## Comments for CAISO 2021-2022 Transmission Planning Process

SDGE appreciates the opportunity to comment on the 2021-2022 Transmission Planning Process. As CAISO gathers assumptions and performs other preliminary work in preparation of the TPP, it is important to consider the following:

**Figure 4.2: NERC PRC-024-1 and IEEE 1547-2003 and Frequency Ride-Through**

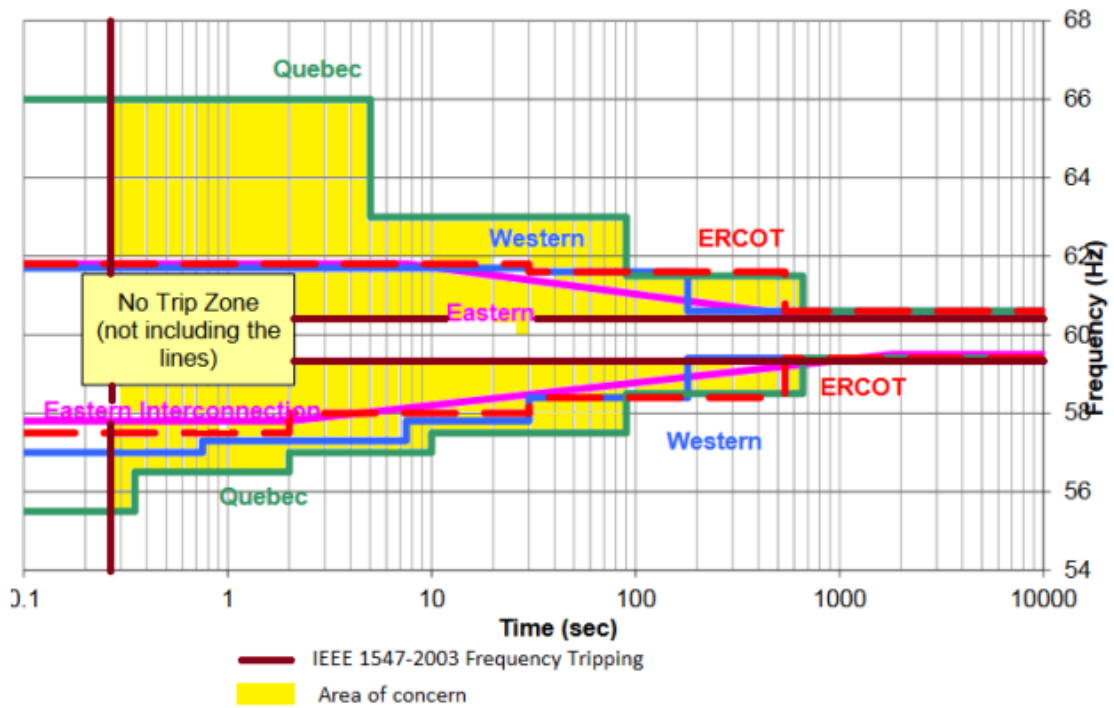
Historically, the CAISO and PTOs have not properly factored in their composite load models how legacy inverters, such as the ones installed before the IEEE1547-2018 standard or the newer Rule 21 requirements, would react during a low frequency event. Legacy inverters that followed mainly the IEEE1547-2003 standard did not have ride through capabilities and were designed to trip 59.3 Hz after 10 cycles (0.16 s). The following NERC report shares the same concerns on legacy inverter and their potential unpredicted behavior if not modeled properly in the TPP models.

PRC-024-2 frequency ride-through requirements are designed such that UFLS schemes will operate before generators begin to disconnect from the BPS. Smaller DER installations, under 30 kW, can begin disconnecting from the BPS without respect to coordination with the area UFLS. When DER disconnect, BPS net load will increase. This will further depress frequency, potentially leading to premature system instability.

SDG&E’s recommendation is for the CAISO and the PTOs to model both the legacy inverters (IEEE1547-2003) and the new inverters (IEEE1547-2018) in the planning models. The number of legacy inverters could be estimated by using data from the “California Distributed Generation Statistics”. As of 2020, the website was showing of the ~8000 MW of BTM-PV installed today in California, ~5000 MW were installed before the first round of smart inverter requirements rolled out on 9/8/2017 (i.e. legacy inverters). If needed, this data can be further improved and disaggregated at the PTO level.
